TENDER 20-01
HIGHWAY 19A PHASE 3 – CIVIL WORKS
ADDENDUM NO. 2

March 13th, 2020

Addendum Item 1 – Questions & Answers

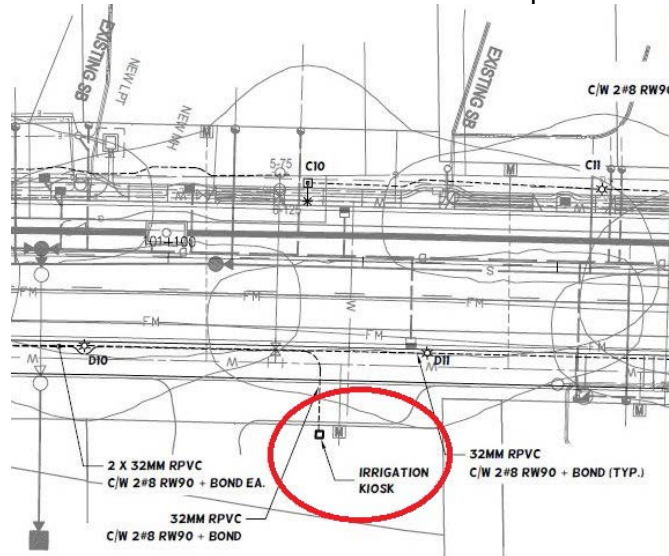
Please confirm that all poles are to be powder coated black to match the kiosks.

Confirmed, the poles and kiosks should match.

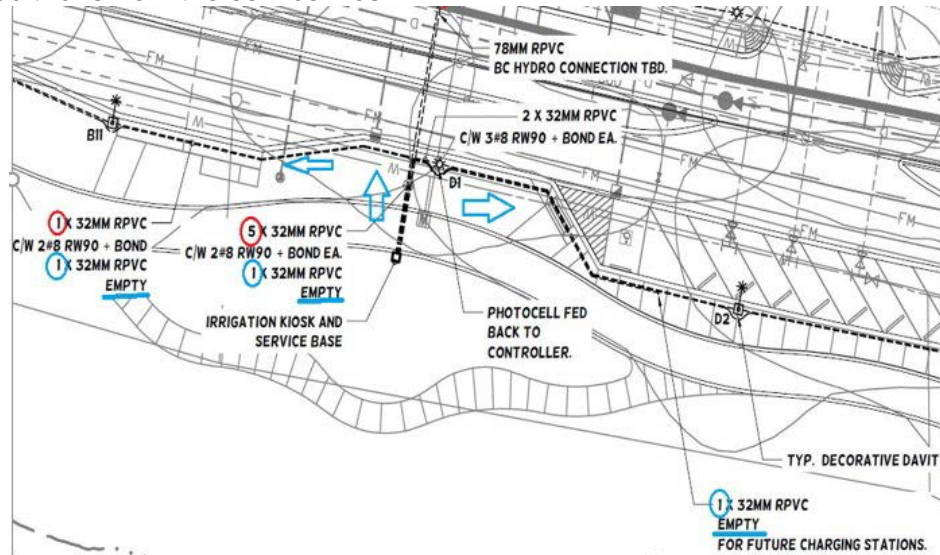
Conduit spare runs from the Service Kiosk. There is only (1) empty run leaving the kiosk but then turns into (2) empty runs going (2) different directions without a JB? Should there be (2) empty conduit runs from the service kiosk?

The end of each run is shown and both empty conduits are required. The north empty conduit is for future charging stations shown same detail, and the south empty conduit is shown run to the centre of the traffic circle for future feature lighting, Sheet E-1, Detail 2. The error is in the label leaving the kiosk; the label should read 2 x to indicate that there are two empty conduits leaving the kiosk.

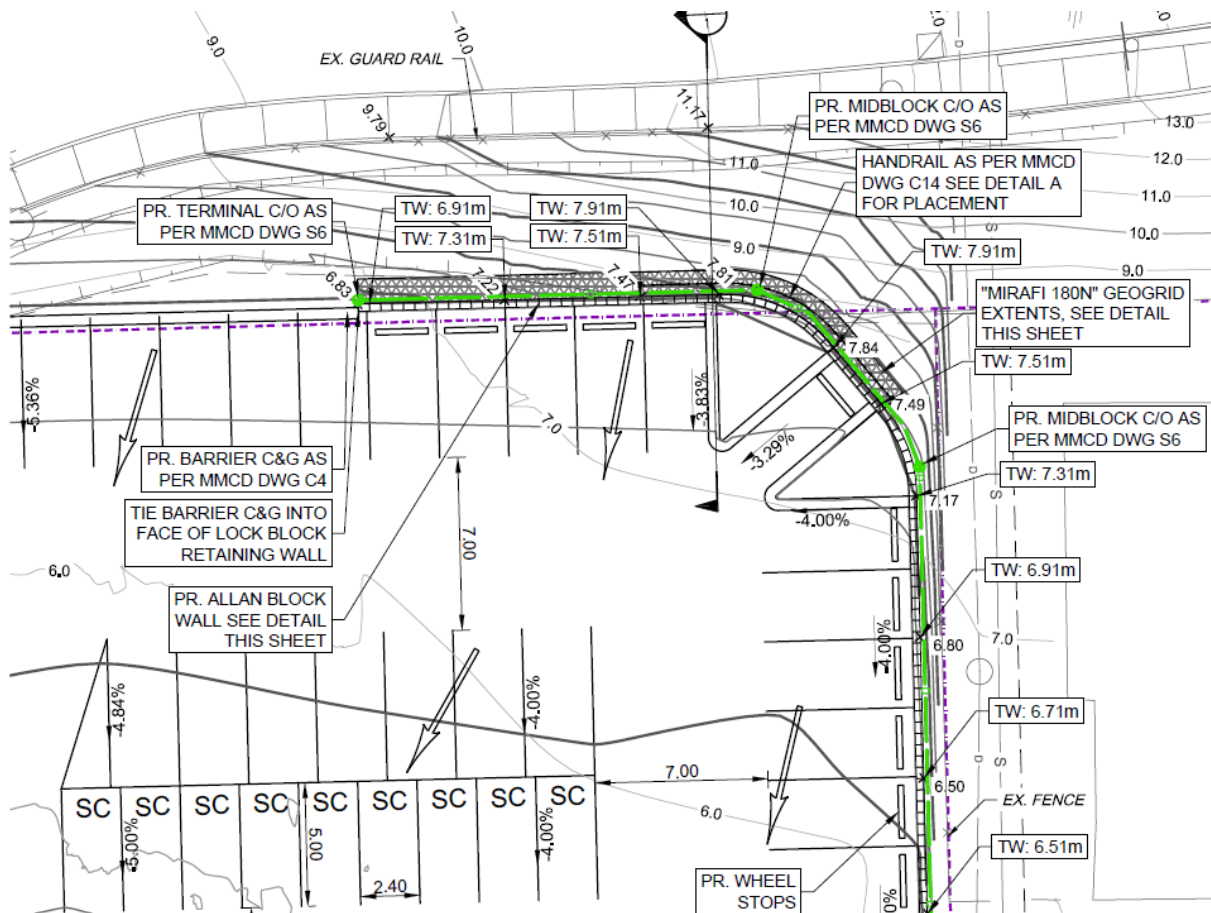
Page R-16 shows an allan block wall in the parking lot without curb and gutter beside it. Page R-2 shows curb and gutter going around the entire parking lot. Could you please confirm if there is curb and gutter beside the allan block wall.

Per the sketch below there is no curb in front of the Allan Block wall. In addition, the plan shows the required extents for the geo-grid installation shown as a hatched area behind the wall.

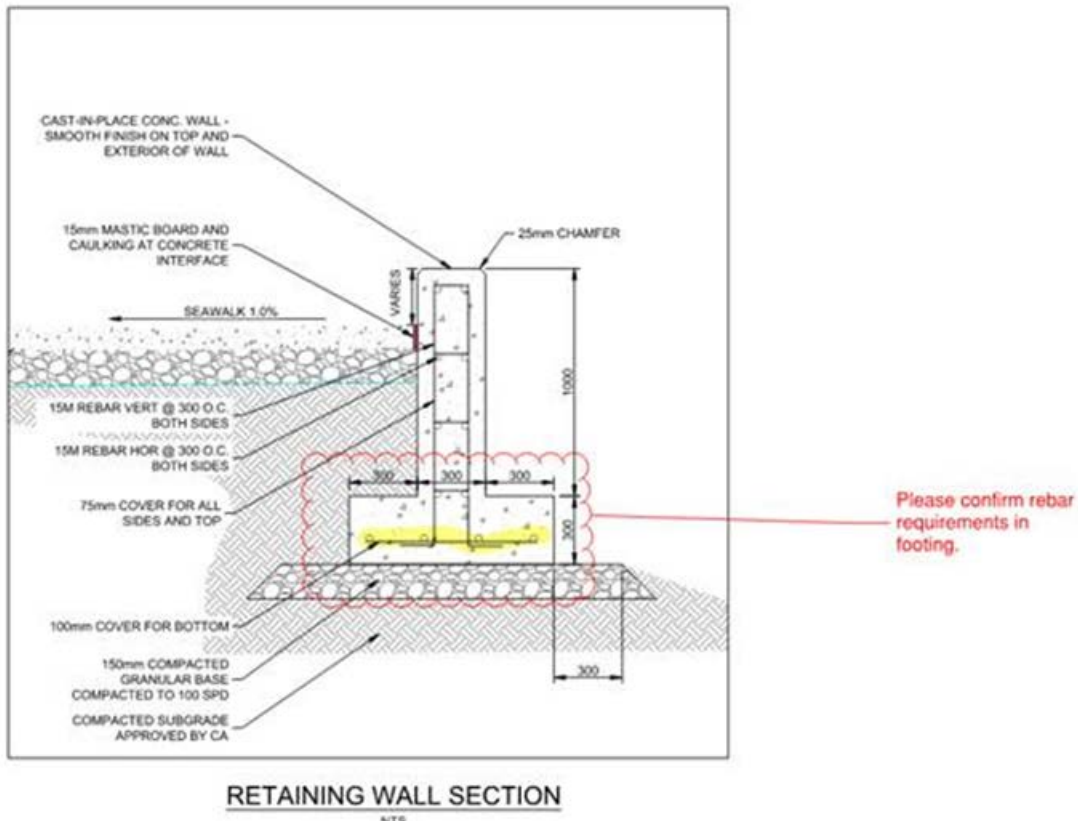
Item 64. Decorative Handrail. The drawings (C16 and C 17) do not show much detail regarding the decorative handrail (only a cross section). Thickness of metals, cable size, cable type and tension, post spacings, anchor bolt size, etc are required. Is there a specification and drawing package available for this item, or alternatively, is there an approved manufacturer where these are a stock items.

This is a custom railing. A precedent image is included below. Other details include:

- Metal tubing shall be of medium thickness – 3.55mm
- All Cable to Galvanized Steel Cable – 8mm 6X19 or 6x25 cable
- Cable tension between posts to be able to withstand 500 lbs of force across 2 cables
- Anchors to be 4 per post – Hilti KB 12x180 or equal
- Shop drawing to be stamped by a Professional Engineer registered with EGBC
- Post spacing to be 1800MM centre to centre

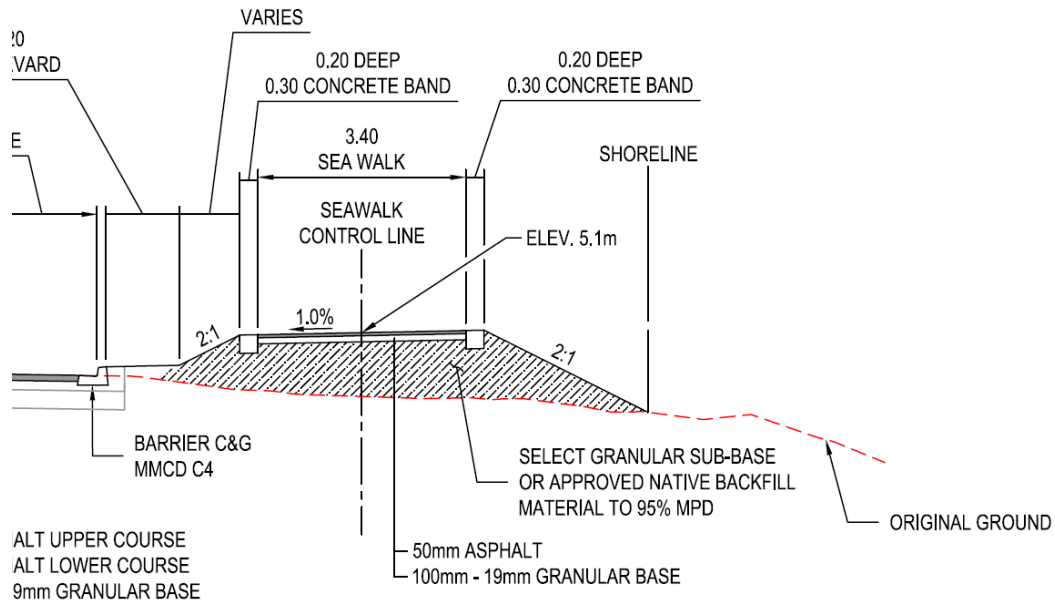
Item 52. Seawalk Gravel Berm. There is only a total quantity for the material, but there is no gradation spec. (MMCD Setion 31 24 13 1.8.13 calls for low permeability granular material), location, or detail of the size of the berm. Is this general gravel fill under the seawalk, or is this a temporary berm for sediment and erosion control purposes? Can you please provide the gradation spec, detail and location of this berm.

Item 52. Seawalk Gravel Berm is intended to be the pay item for the construction of the portion of the "raised" seawalk as shown below. Specifications for the required material and compaction are provided on the *Drawings*.
